TITEL: Kontroll av bultar i huvudrotorväxel

GÄLLER: Modell R44 med installerad huvudrotorväxel P/N C006-1 Revision A
t o m P.

DATE: August 29, 1996
96-18-22

96-18-22 ROBINSON HELICOPTER COMPANY: Priority Letter issued August 29, 1996. Docket No. 96-SW-25-AD.

FIGURE 1

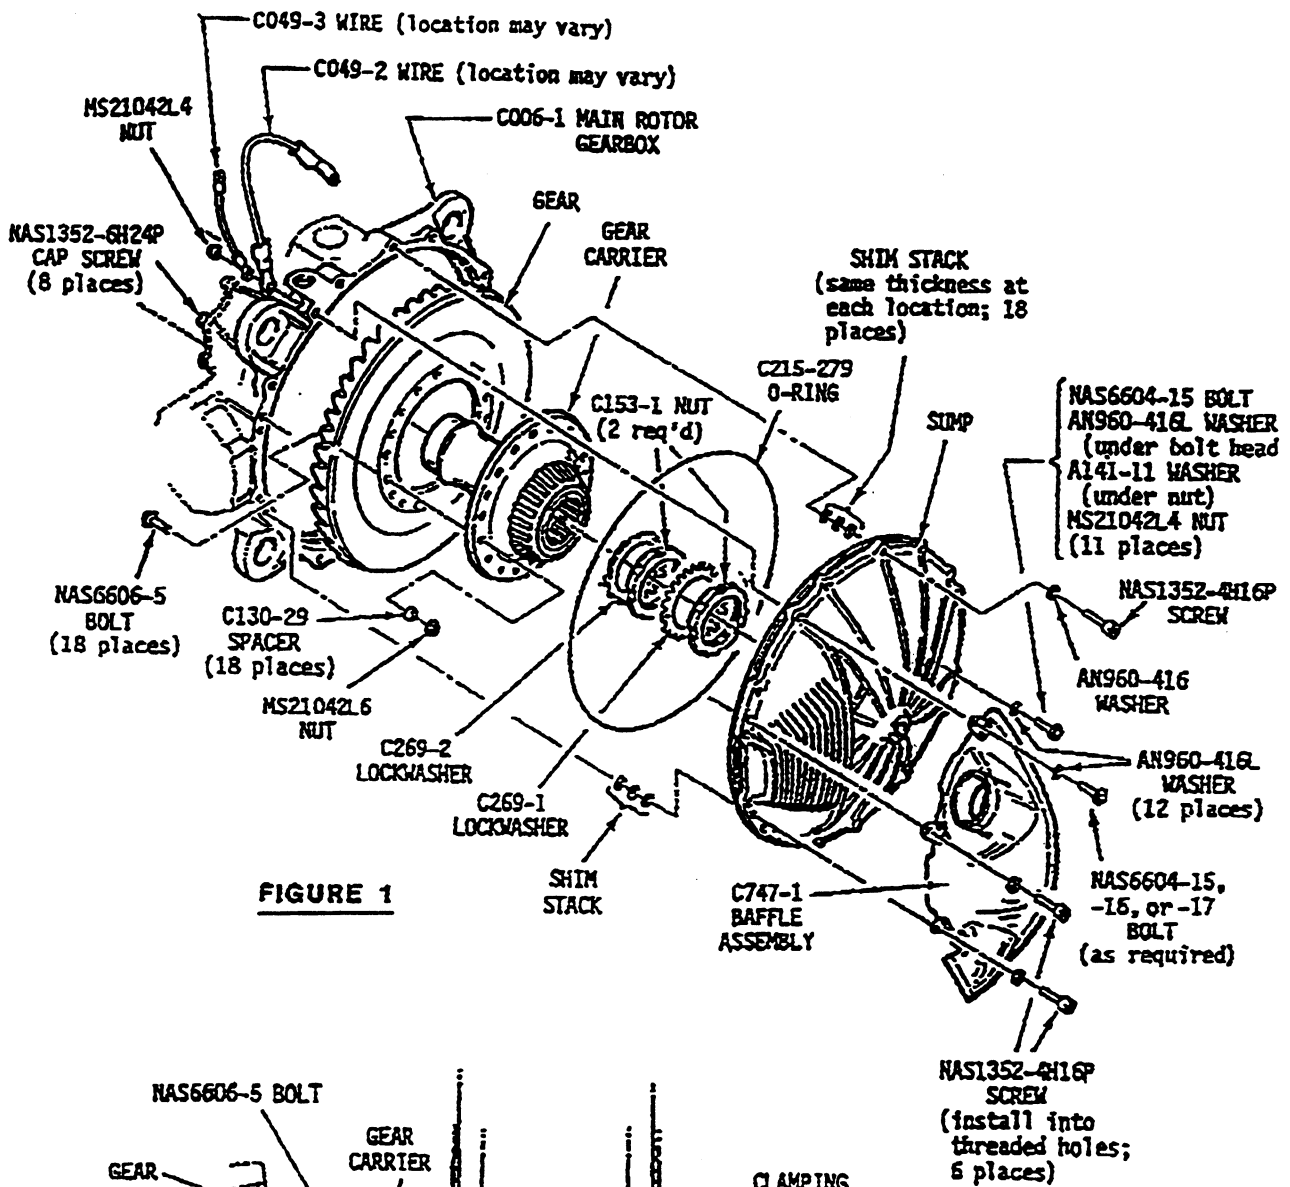
- (a) Drain the oil from the gearbox, part number (P/N) C006-1, and remove the gearbox from helicopter.
- (b) Lay the gearbox on its side with input yoke up. Loosen the eight cap screws attaching the mast tube to the gearbox, but do not remove the screws. Remove the twelve bolts and six cap screws holding the sump and baffle in place (Figure 1). Note the location of ground wires.

FIGURE 2

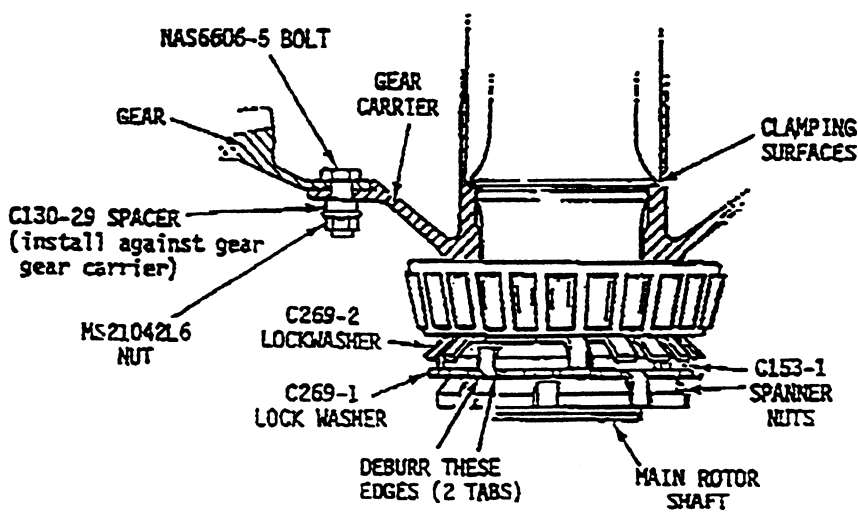
(h) Align the gear to the gear carrier and install NAS6606-5 bolts, spacers, P/N C130-29, and MS21042L6 nuts in 18 places (Figure 2). Keep the mating surfaces and hardware dry, clean, and free of oil. Torque the nuts to 40 ft.-lb. (includes self-locking torque) using the torquing sequence shown on Figure 3.

(l) Before installing the unused lockwasher, P/N C269-1, note that the edges are sharp on one side and rounded on the other. De-burr the sharp edges on two opposite tabs (Figure 2). This will reduce the chance of cracking when these tabs are bent. Install the lockwasher with the de-burred edges toward the first nut.
